# Access Compliance Report

## Public Rights-of-Way

### (Curb Ramps)

Intersection ID: 19678	Main Street: S_TRYON_ST	Cross Street: OLDE_WHITEHALL_RD	Location: NW
ADA ID: 348A9E111292	Ramp Type: PerpDiag	Initial Pass/Fail: Fail	Overall Compliance: No
		Severity Score: 12.5

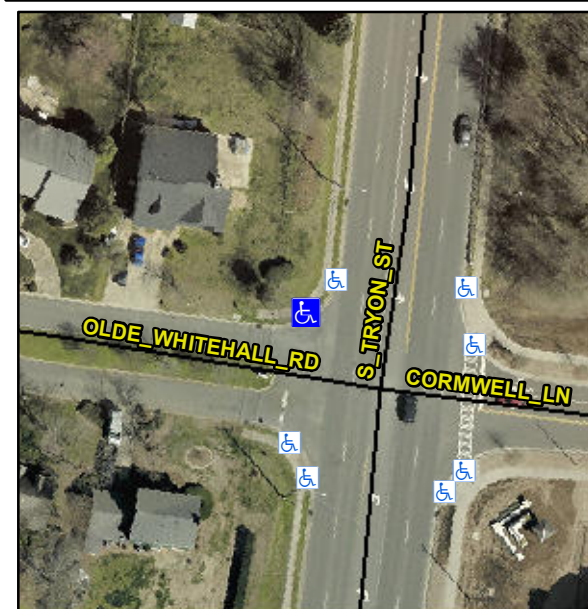
**Not Found, R304.2.2**

Compliance	Description	Data	Compliance	Description	Data
N/A	Ramp Length (in)	90.0	No	Ramp Slope (%)	8.8
Yes	Ramp Width (in)	48.0	Yes	Ramp XSlope (%)	0.1
N/A	Flare Type LT	N/A	N/A	Flare Type RT	N/A
N/A	Flare Slope LT (%)	N/A	N/A	Flare Slope RT (%)	N/A
N/A	Flare Traversable LT?	N/A	N/A	Flare Traversable RT?	N/A
N/A	Landing Length (in)	N/A	N/A	DWS Provided?	N/A
N/A	Landing Width (in)	N/A	N/A	DWS Contrast?	N/A
N/A	Landing Slope (%)	N/A	N/A	DWS Length (in)	N/A
N/A	Landing X Slope (%)	N/A	N/A	DWS Full Width?	N/A
N/A	Landing Curb? (Y/N)	N/A	N/A	DWS Offset (in)	N/A
N/A	Shared Landing?	N/A			
N/A	Gutter Ponding?	N/A	N/A	Gutter Slope (%)	N/A
N/A	Gutter Lip Ht (in)	N/A	N/A	Gutter X Slope (%)	N/A
N/A	Painted X Walk1?	No	N/A	Painted X Walk2?	No
	X Walk 1 Direction	To S		X Walk 2 Direction	To E
N/A	X Walk 1 Width (in)	N/A	N/A	X Walk 2 Width (in)	N/A
	X Walk 1 Slope (%)	2.9		X Walk 2 Slope (%)	2.4
	X Walk 1 X Slope (%)	2.6		X Walk 2 X Slope (%)	0.3

**Remove & Replace Curb Ramp With Two New Directional Ramps or Equivalent.**
